UNITED STATES PATENT AND TRADEMARK OFFICE

APPLICATION NO.	FILING DATE	FIRST NAMED INVENTOR	ATTORNEY DOCKET NO.	CONFIRMATION NO.
09/619,665	07/19/2000	Shigeto Kamata	684.3049	2162

Office Action Summary

DETAILED ACTION

FIG. 13

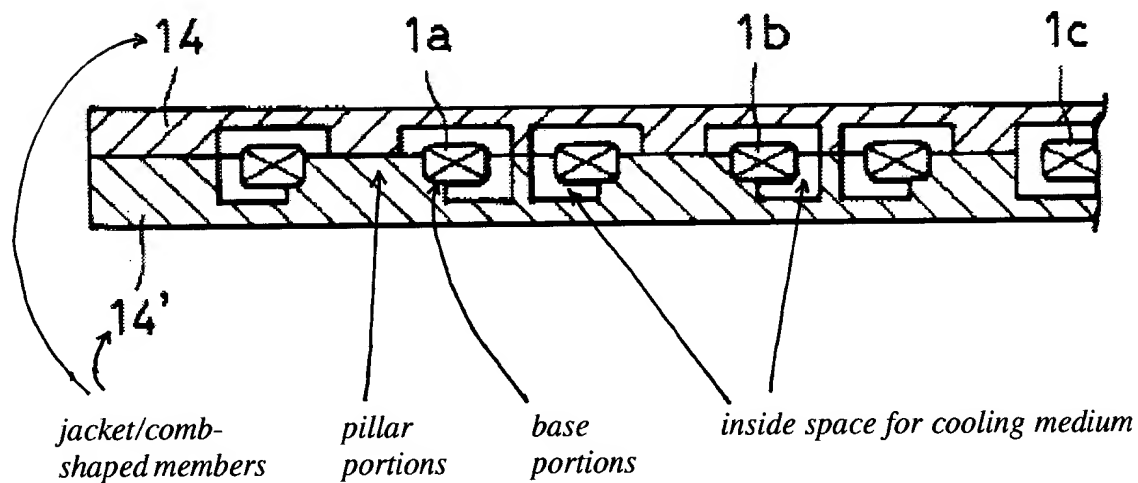
4. Claims 20-26 are allowed. Regarding claim 20, Kamata teaches a linear motor including magnets 3 (Fig.5) and coil holder or “jacket” 14 (Fig.10) formed in a comb-shape, plural coils 1a/1b/1c (Fig.13), plural “recessed” or “base portions” (not numbered, see Fig.13), and plural pillar portions 8a/8b/8c disposed in a first (longitudinal) direction of relative movement between the magnet and coil (Fig.13). Each coil is supported with respect to a second (transverse) direction by the “recessed” or “base” portions. However, there is no teaching or disclosure that the pillar portions are disposed along an outside periphery of the coils, i.e., that the pillar portions contact the coils on the outside periphery of the coils. As best seen in Fig.13, the pillar portions contact the inside periphery of the coils 1a/1b/1c of Kamata.

5. Applicant's arguments filed 11-26-02 have been fully considered but they are not wholly persuasive. Regarding independent claim 1, applicant argues that Kamata “fails to disclose or suggest a coil that is supported by base portions in a floating manner and is fixed, with respect to the driving direction, by being sandwiched by the pillar-like portions.”

In response, the examiner points out that Fig.13 of Kamata discloses a comb-shaped member including base portions and pillar-like portions connecting the base portions. The base portions in Kamata comprise step-shaped indentations in the pillar portions. The base portions further support the coils 1a/1b/1c "in a floating manner," i.e., such that a space exists between either side of the coils and the jacket covers 14/14'. Cooling medium in the jacket can thus flow in the space, on both sides of the coils (c.5, lines 53-65).

Further, the coils are "fixed with respect to the driving direction" by the base and pillar portions and the pillar portions "sandwich" the coils. See c.5, lines 13-20 where in the first embodiment (Fig.3) a pair of cooling plates 42b are described as "sandwiching both sides of the [coil] row 42a."
